SEWAGE DISPOSAL SYSTEM

HOWARD COUNTY HEALTH DEPARTMENT
 BUREAU OF ENVIRONMENTAL HEALTH

Drawn: KBW	PLOT PLAN FOR BUILDING PERMIT	Scale: 1"=50'
Designed: SOH	H. MULLINEAUX PROPERTY	Drawing: 1 of 1
Checked: BDB	TAX MAP No. 0 P10 PARCEL 15 5th ELECTION DISTRICT HOWARD COUNTY, MARYLAND	LDE:bbNb 96-035
Date: 6/96	BUILDER SELFRIEDGE BUILDERS, INC. 14045 Bared Drive, Glenwood, MD 21738 (410) 793-2800	File No.

(page 1)
RE: Plot Plan for Building Permit
ie. Sand Mound Design Plans
~~For the H. Mullineaux Property~~
Byrd Property (aka. H. Mullineaux
Property)
Windsor Forrest Road.

TYPICAL SAND MOUND CROSS SECTION
Not To Scale

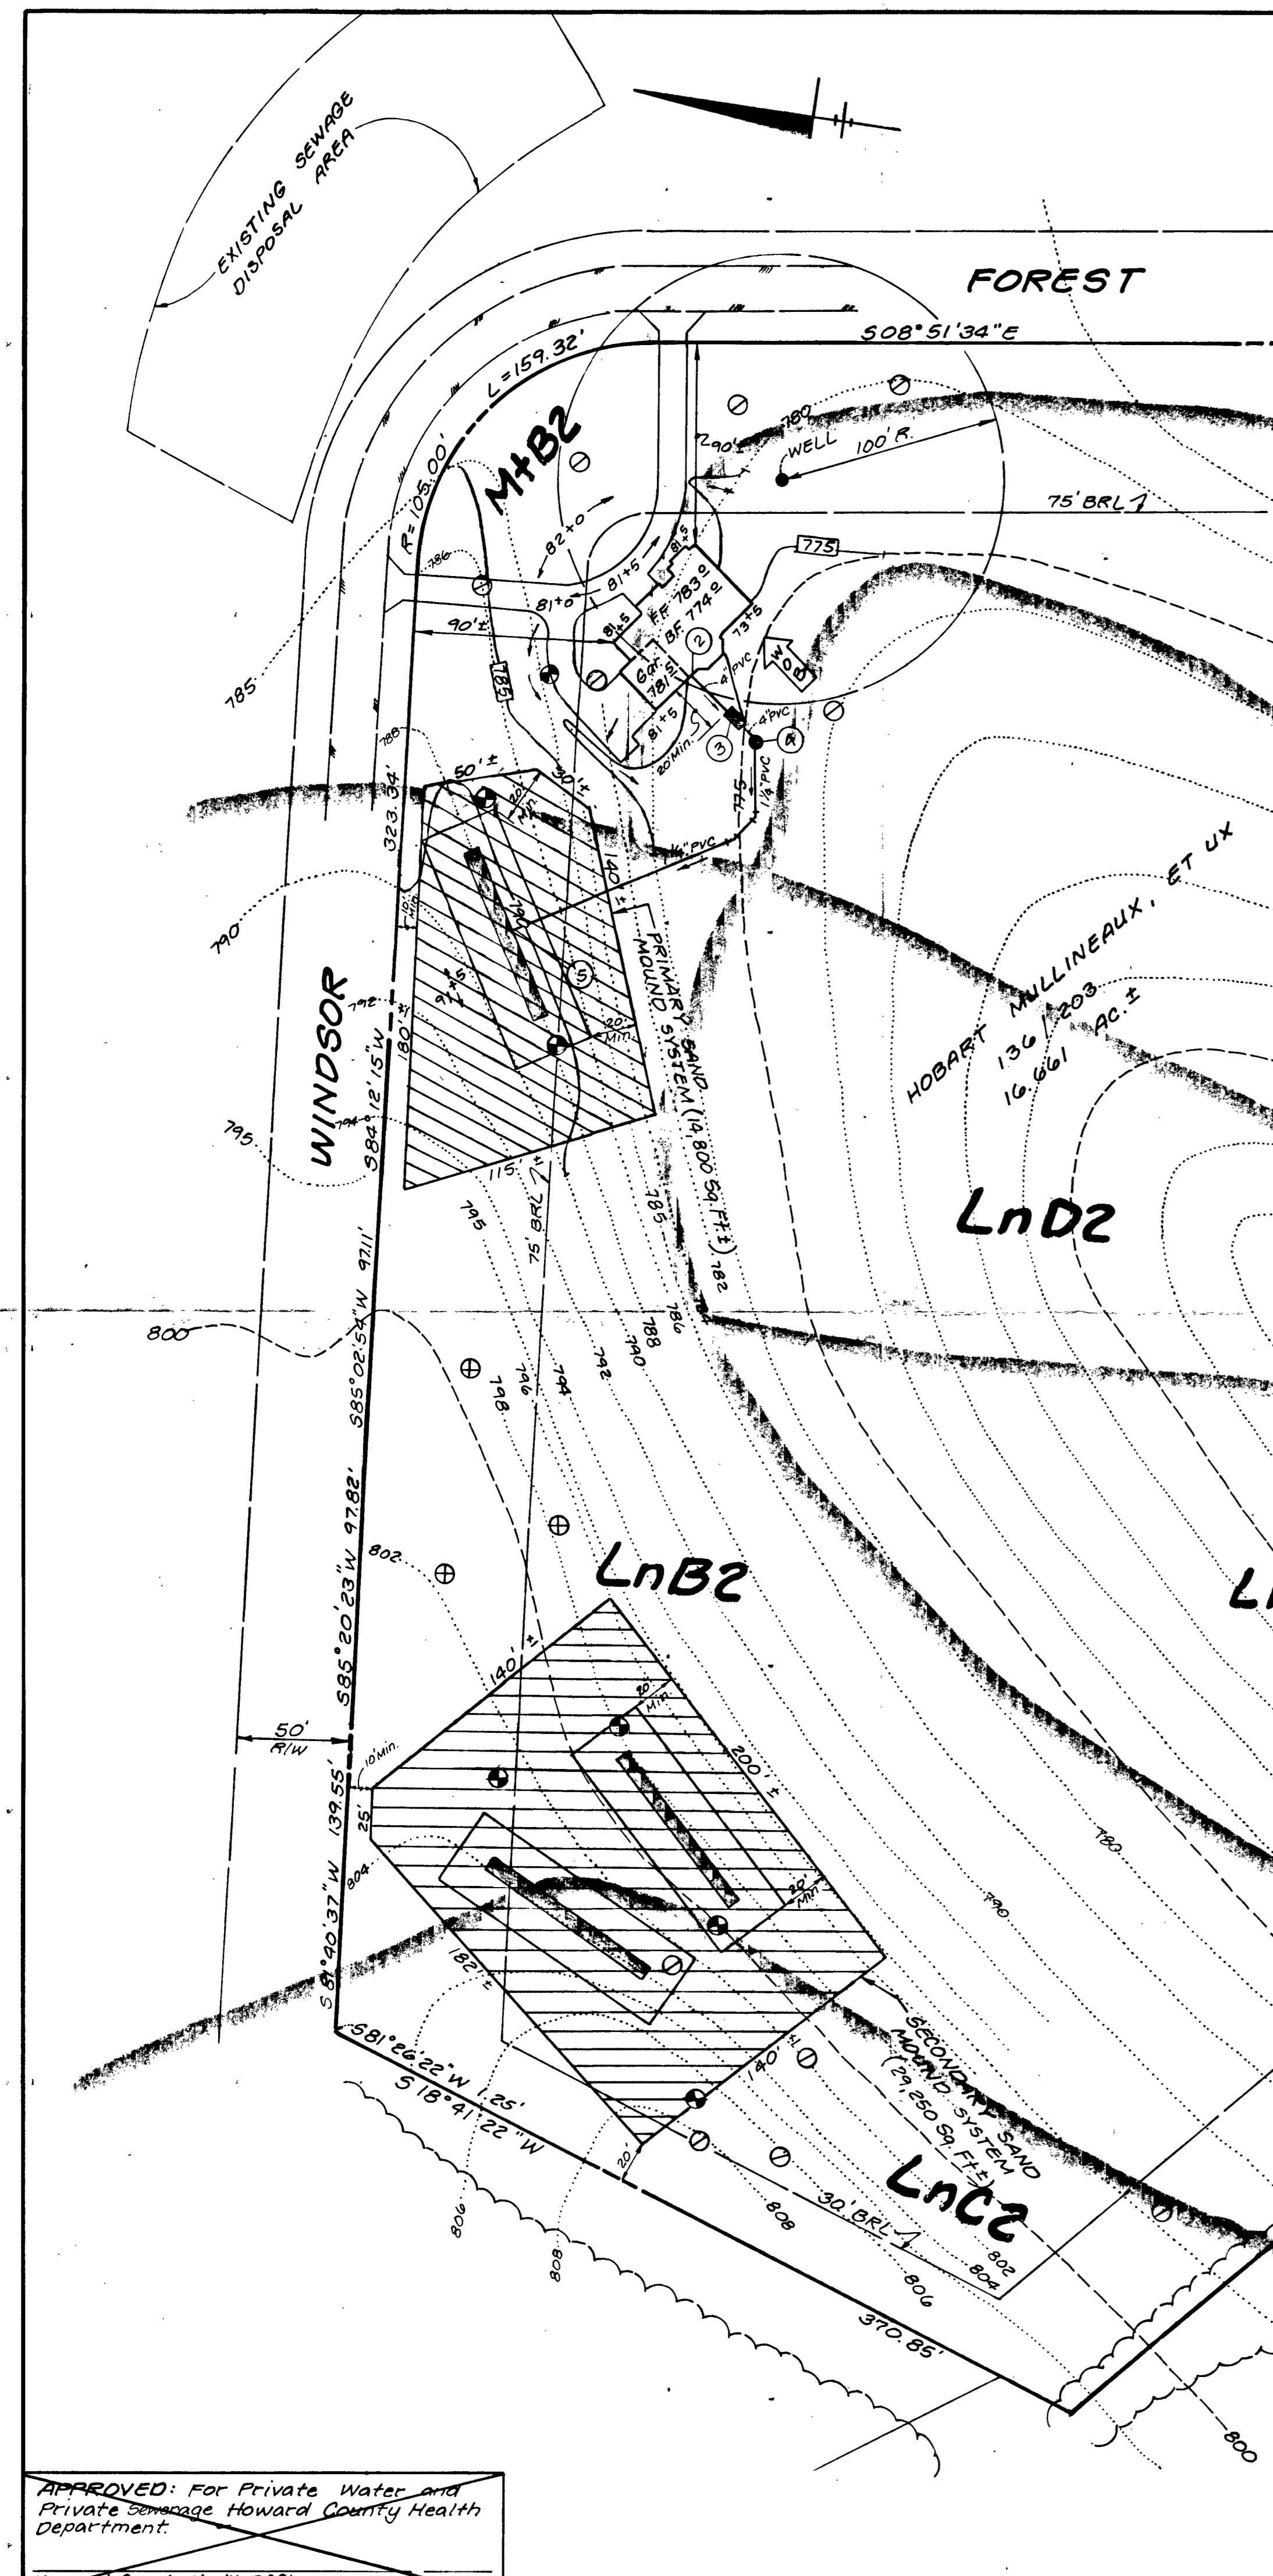
① The 2 ft contour intervals show slopes greater than 12% within the 20 ft immediate downslope of the lower repair sand mound site (varies between 15 and 25% slope) and immediately adjacent to the south west corner of the primary mound site (25% slope). As this condition may have an adverse impact on the proper functioning and future repair alternative for the Sand Mound in question, the solution to this problem needs to be adequately address. Possible repositioning of the primary Sand Mound at the final stake out inspection or relocation of the primary Sand Mound to the uppermost Repair Site are possible solutions, since the well is already drilled and house is well along in its construction.

② a second pump chamber and pump (ie. pump pit and dousing chamber are synonymous terms) and pump appear redundant, a single chamber and pump system should be adequate. (Show change here and on

- ④ ~~Set~~ straw or mulch hay is not acceptable backfill barrier. Use geotextile fabric (change here and in S17 Construction Sequence - C.4)
- ⑤ 6" minimum for top soil cover.
- ⑥ with 1 1/2" diameter pipe, 10" (not 9") washed gravel would be required
- ⑦ (this change affects all S17 dimension calculation slightly)
- ⑧ Show 2" of gravel cover over 1 1/2" pipes.
- ⑨ change down slope & up slope dimensions (discussed later)
- ⑩ Perforations should be 5/16" - if use 1/4" perforations, include a Sand Filter pre-treatment ^{unit} to reduce probability of perforation hole clogging in design. (show change in calculations and piping schematic)
- ⑪ The last perforation should be centered or in the elbow of a turnings to prevent vapor lock in the pipes.
- ⑫ change perf. spacing if necessary.

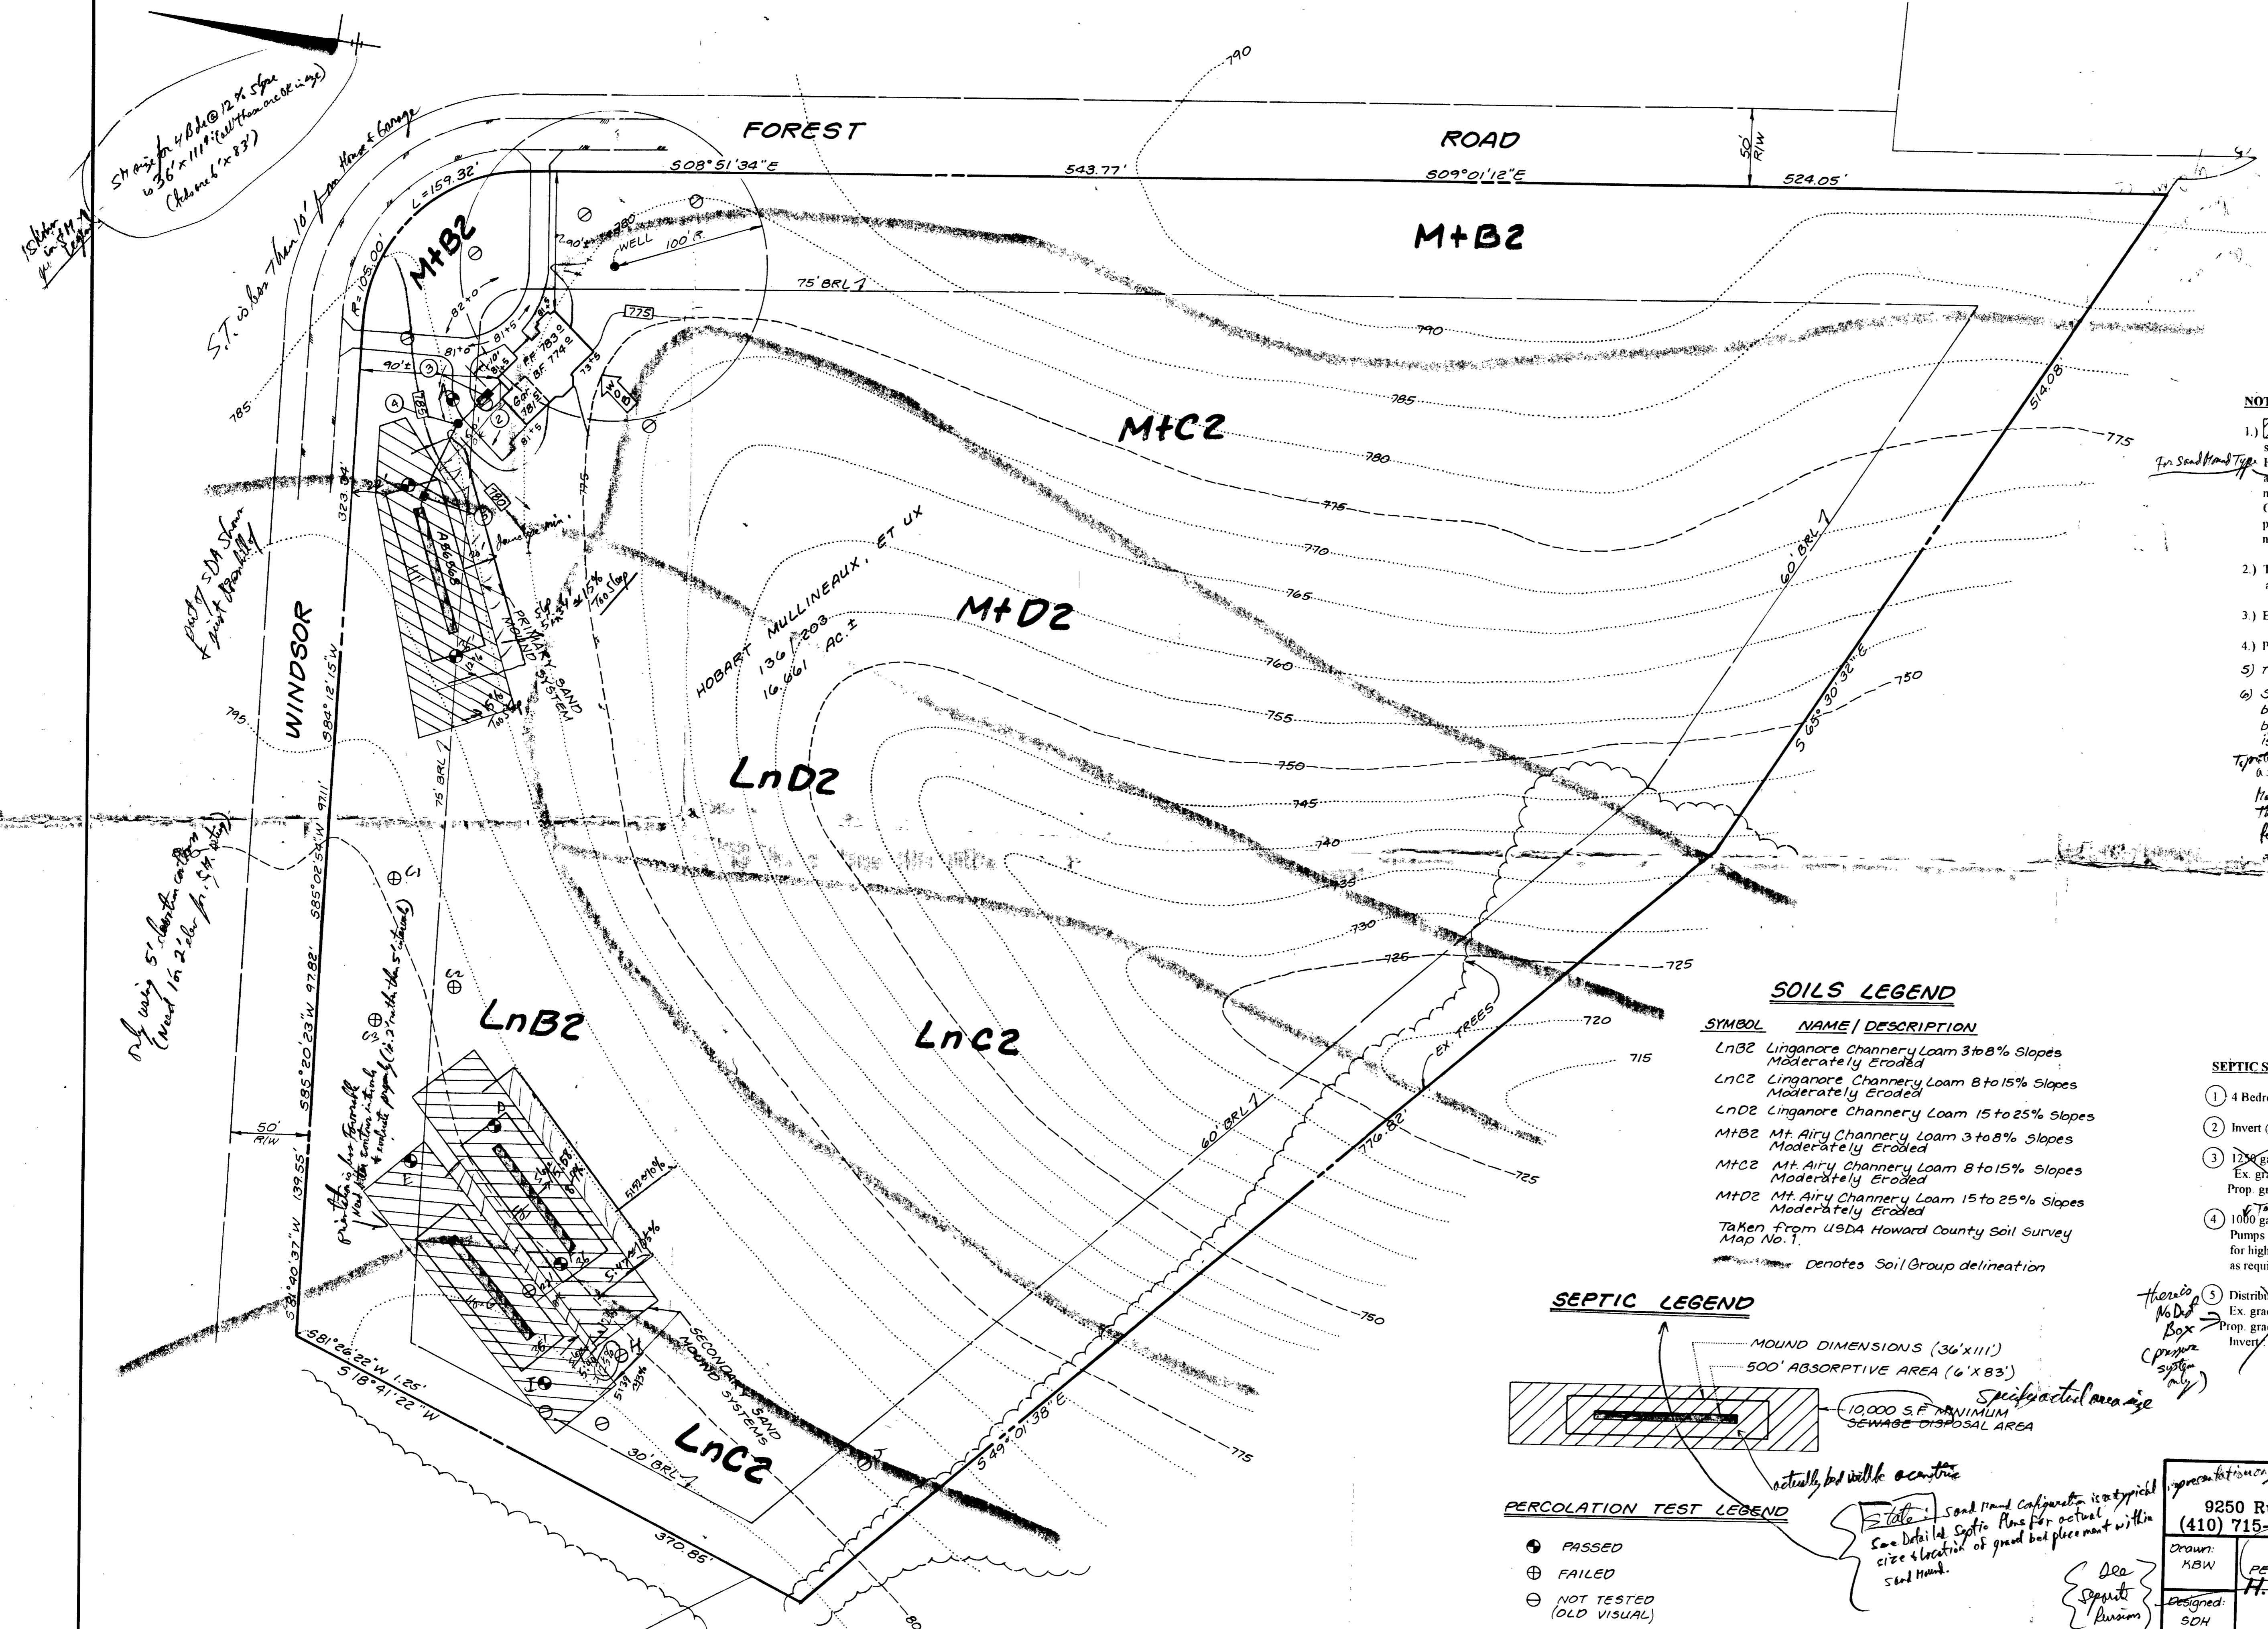
- 4 Bedrooms.
- Invert @ wall : 771.50 *Top Sealed 2 checked ST (1500 gal) repaired*
- 1200 gallon septic tank. Provide manhole to grade. Ex. grade over tank : 783.5 Invert In : 771.30 Prop. grade over tank : 781.8 Invert Out : 771.00 *Top Sealed required*
- 1000 gallon pump pit with dual effluent pumps. Pumps shall be equipped with audible and visual alarm system, on separate circuit, for high water and pump malfunction. Install check valves as required. Invert In : 770.60

FIGURE 7-28

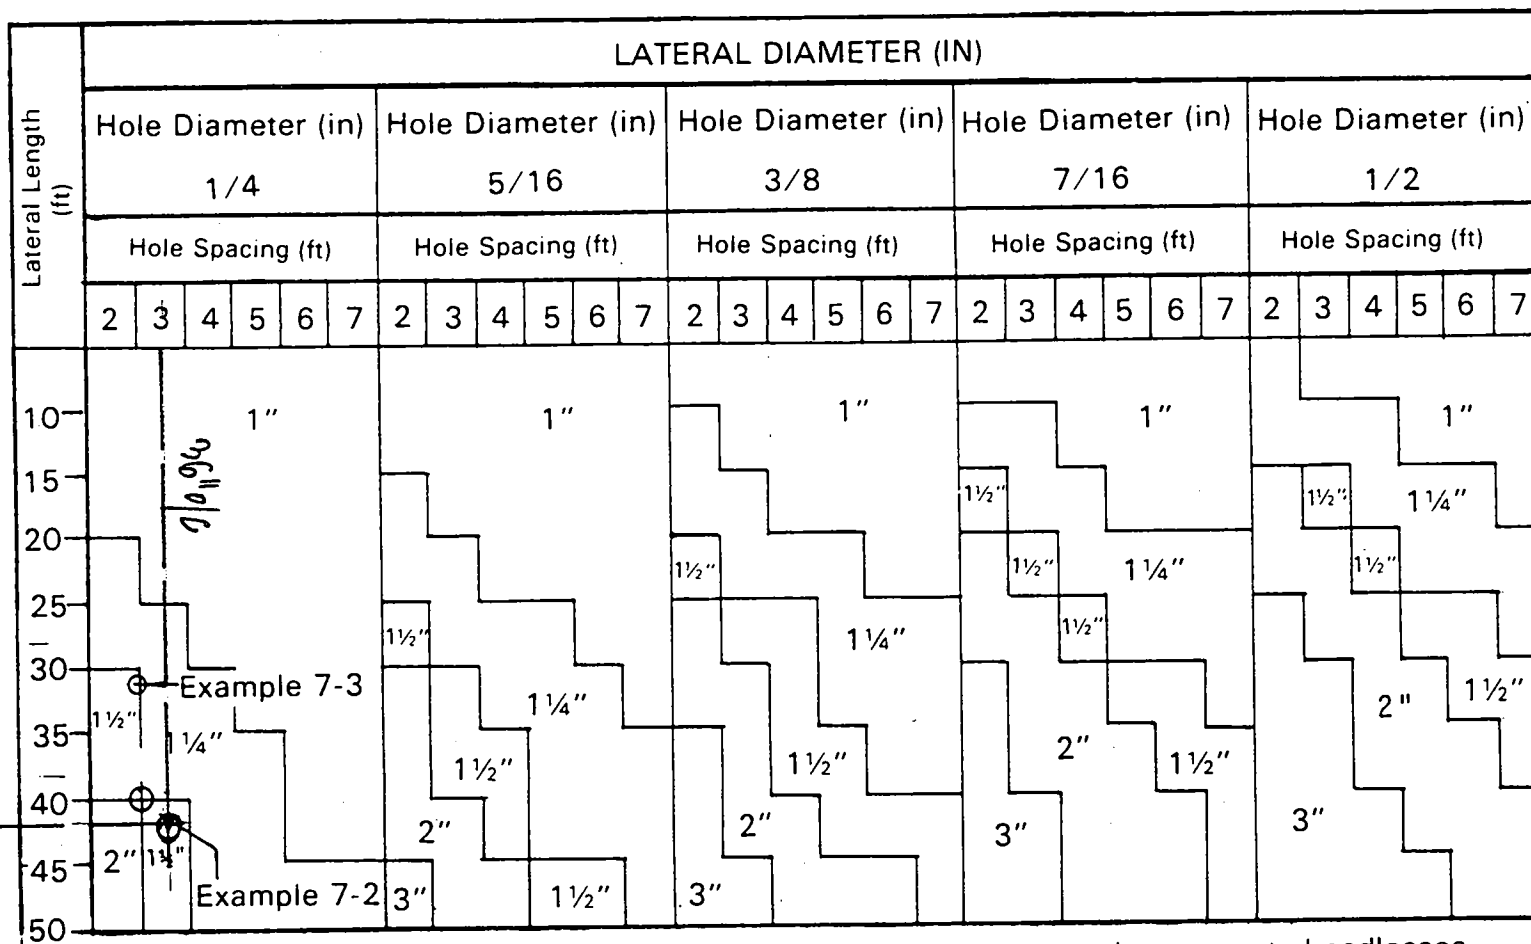
Note
preferred (or explain reason for difference - if 1/4" necessary pretreatment with a sand filter or other device to remove fines from effluent will be required)

prefer to size hoses @ 6 doses/day = 100 gal dose

PIPING SCHEMATIC
NOT TO SCALE

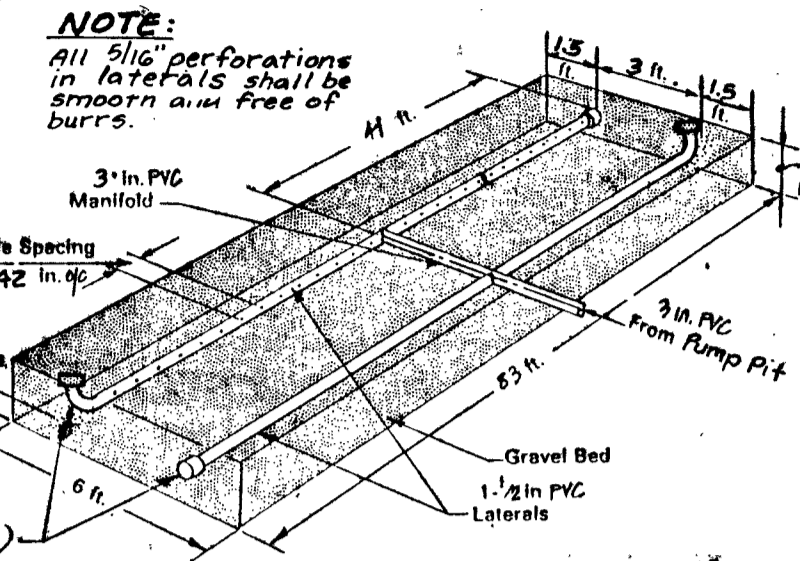
However, based on an inquiry from the septic contractor, Mr. Bill Ingram (Farm and Home Excavating), I have discovered a discrepancy in the size (diameter) of supply line as specified in the plans.

However, the sketch plan and piping schematic both show 1 1/4" PVC for the supply line. The contractor indicates he has already installed 1 1/4" diameter PVC as stipulated on the sketch plan. (Mr. Ingram, apparently, was never provided with a copy of the calculation sheets, in which 3" diameter PVC is mentioned).
